PROJECT LAYOUT SHEET #48	PROJECT NAME: STOCKBRIDGE-BETHEL	PLOT DATE: 3/17/2014
	PROJECT NUMBER: STP 2910(1)	DRAWN BY: W.G.P.
	FILE NAME: z10b214_bdr_nul_48.dgn	CHECKED BY: J.P.S.
	PROJECT LEADER: D.E.G. DESIGNED BY: L.M.B. IPARM FILE: z10b214148.1	SHEET 81 OF 397

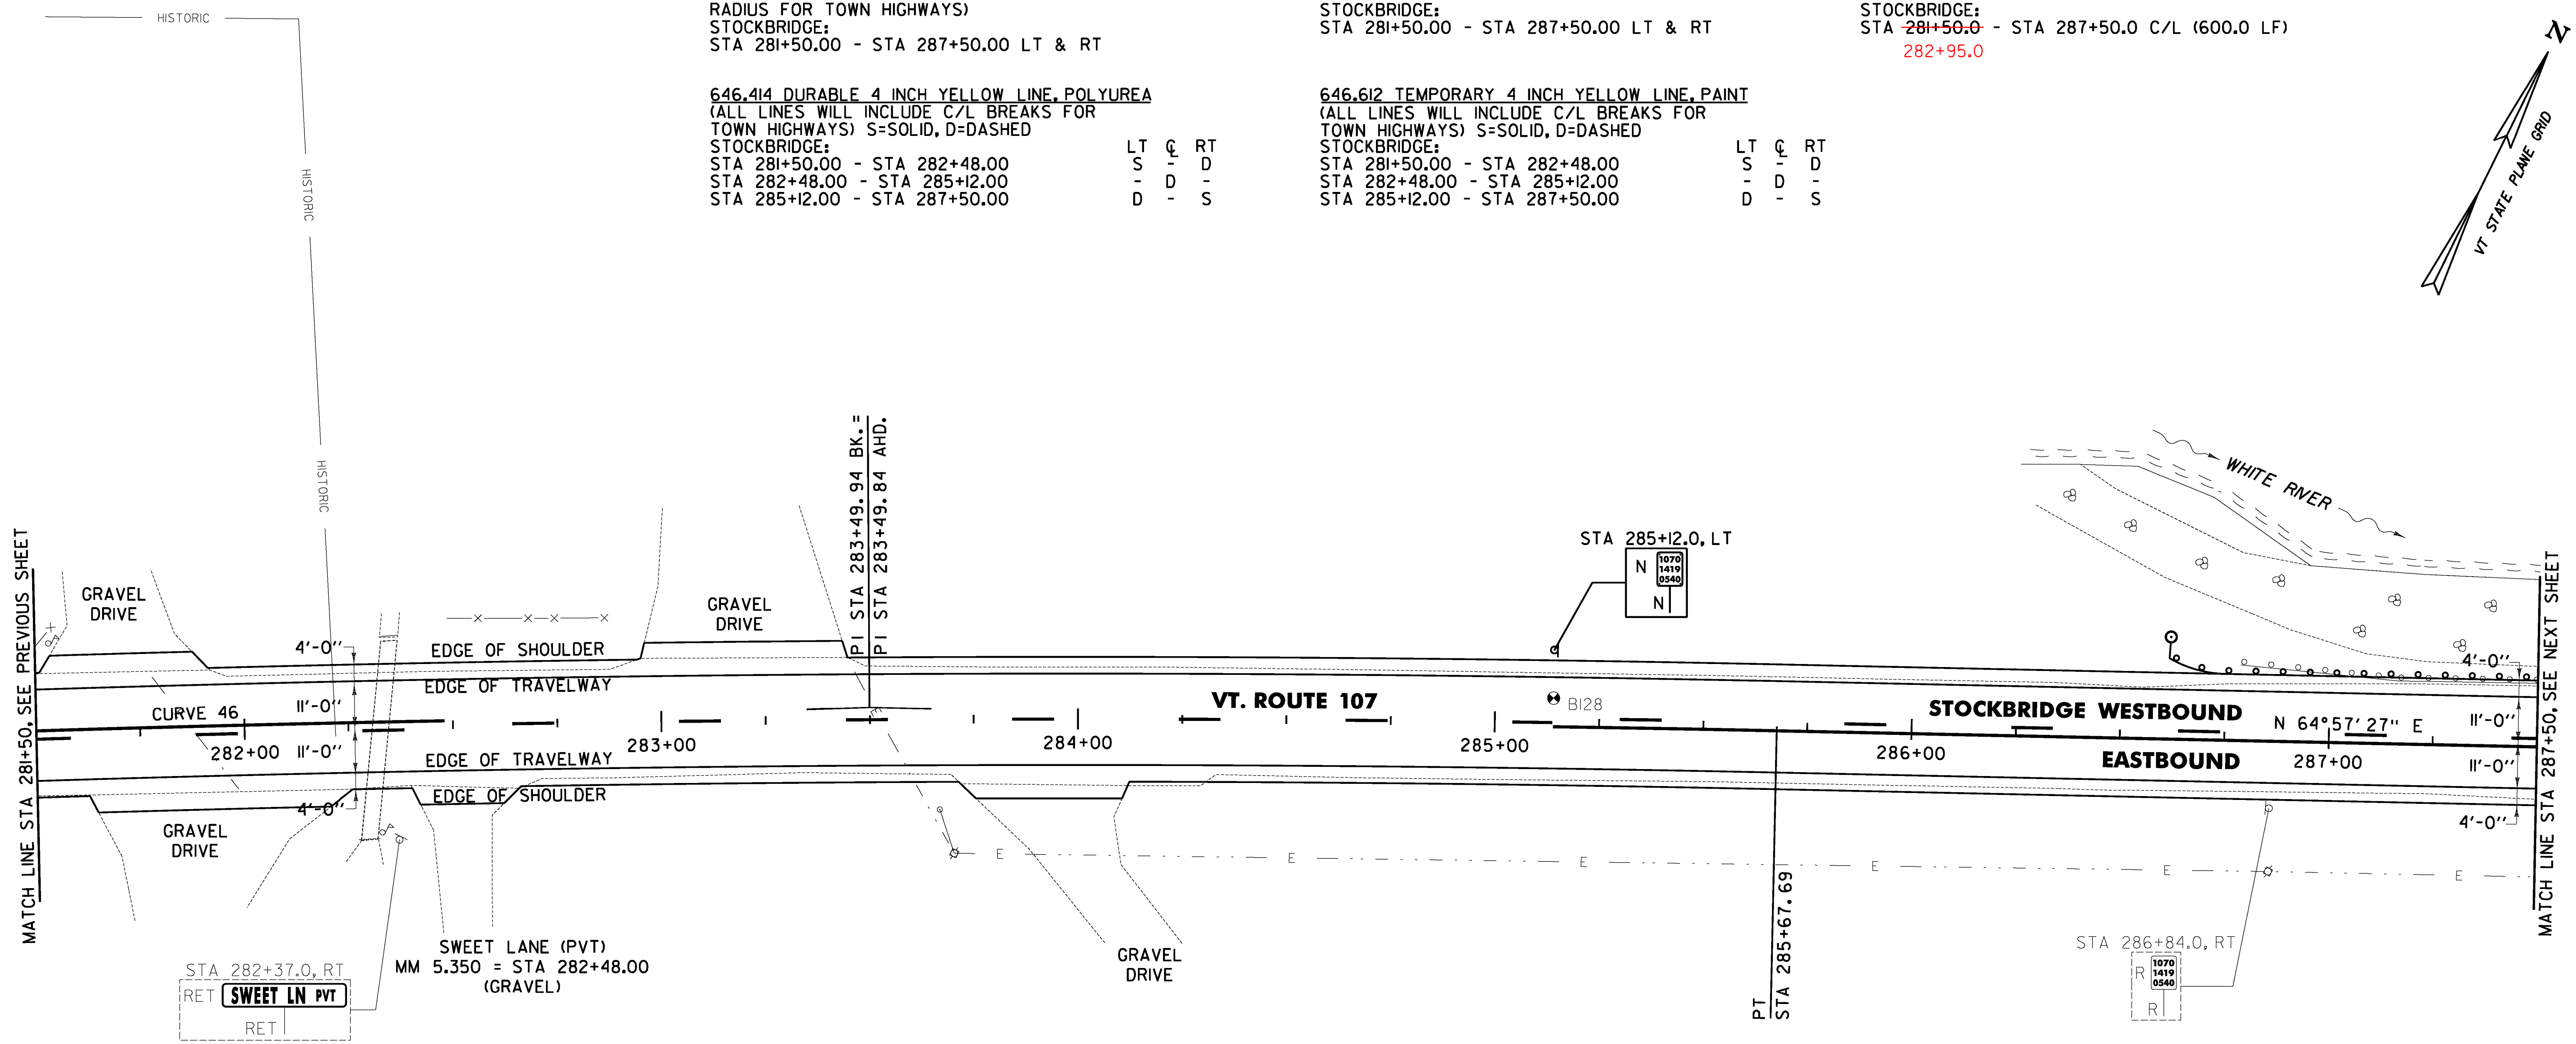
~~646.402 DURABLE 4 INCH WHITE LINE, THERMOPLASTIC OR~~
~~646.404 DURABLE 4 INCH WHITE LINE, POLYUREA~~
 (ALL LINES WILL INCLUDE EDGE LINE BREAKS AND RADIUS FOR TOWN HIGHWAYS)
 STOCKBRIDGE:
 STA 281+50.00 - STA 287+50.00 LT & RT

213.10 MILLED RUMBLE STRIPS
 (ALL CLRS WILL INCLUDE C/L BREAKS FOR TOWN HIGHWAYS)
 STOCKBRIDGE:
 STA ~~281+50.0~~ - STA 287+50.0 C/L (600.0 LF)
 282+95.0
